Proposed Revisions to a Standard Plans Index

Index Number: 700-020

Index Title: MULTI-COLUMN GROUND SIGN

Summary of the changes:

FRONT ELEVATION
BACK ELEVATION
MULTI-COLUMN SIGN ASSEMBLY

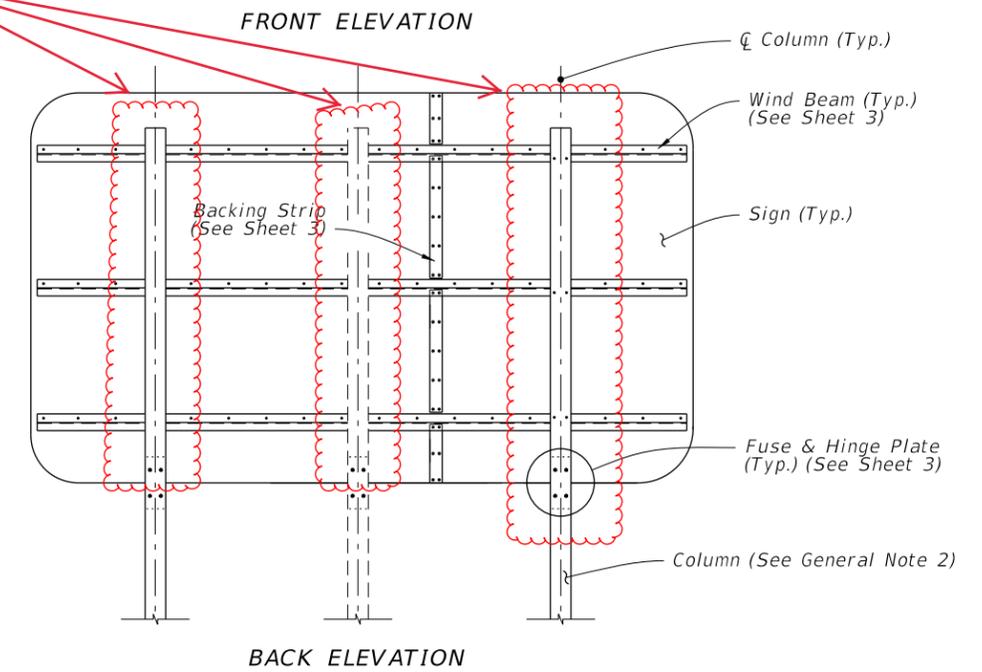
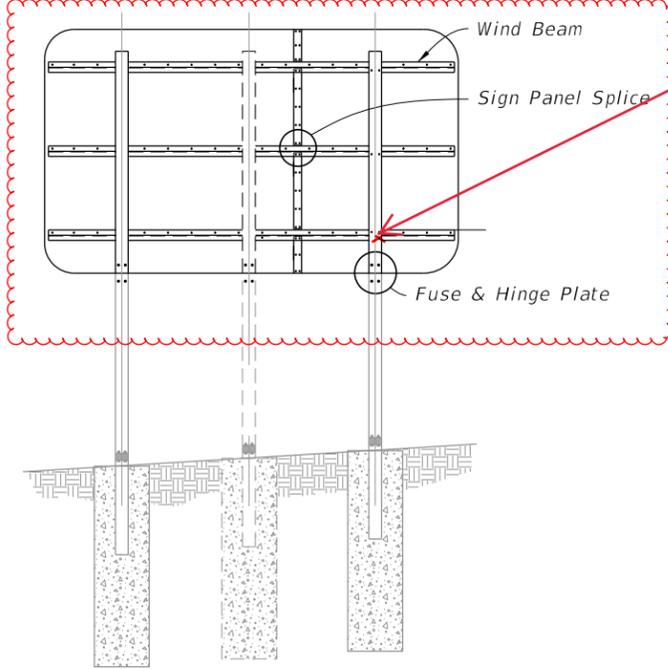
Sheet 1: Revised bolts in the Hanger Beams to show correctly.

The bolts were not showing correctly in the elevation details.

Show the same bolting on the other wind hanger beams

Only 2 bolts per intersection

BACK ELEVATION
MULTI-COLUMN SIGN ASSEMBLY

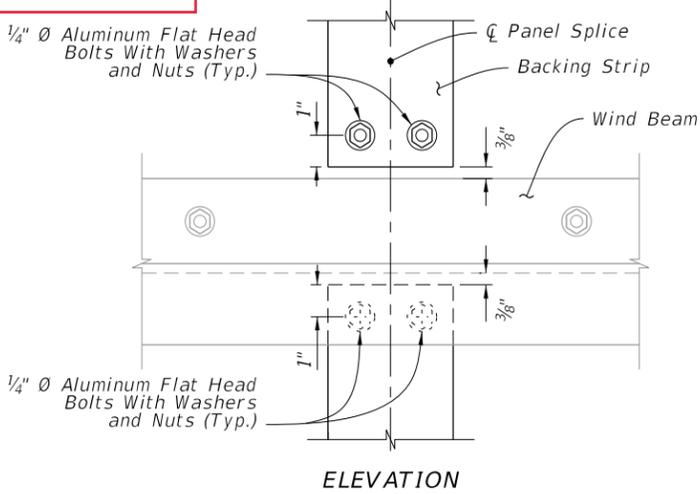
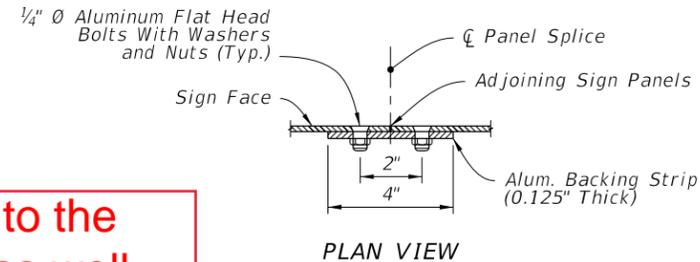
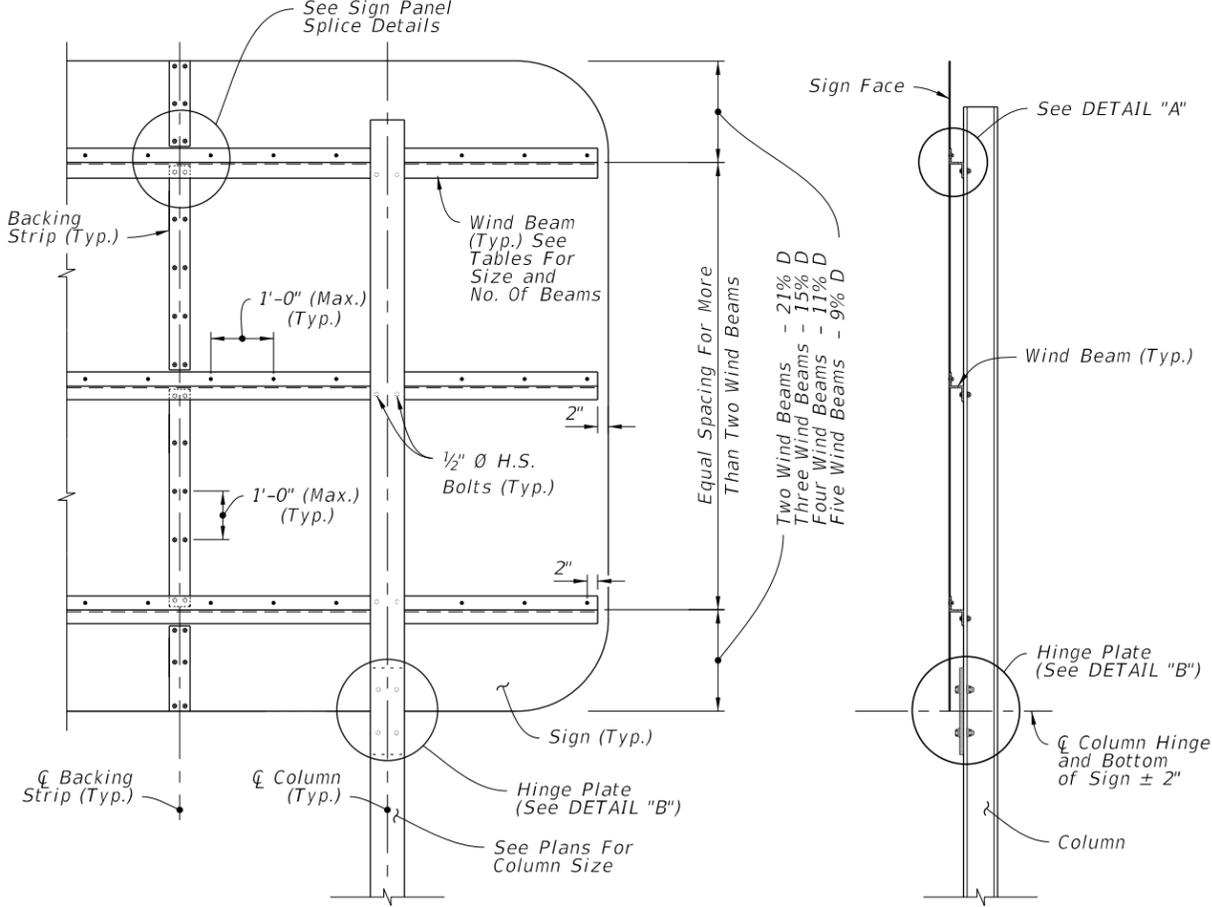
Sheet 2: Revised bolts in the Hanger Beams to show correctly.

Add the bolts to the other beams as well
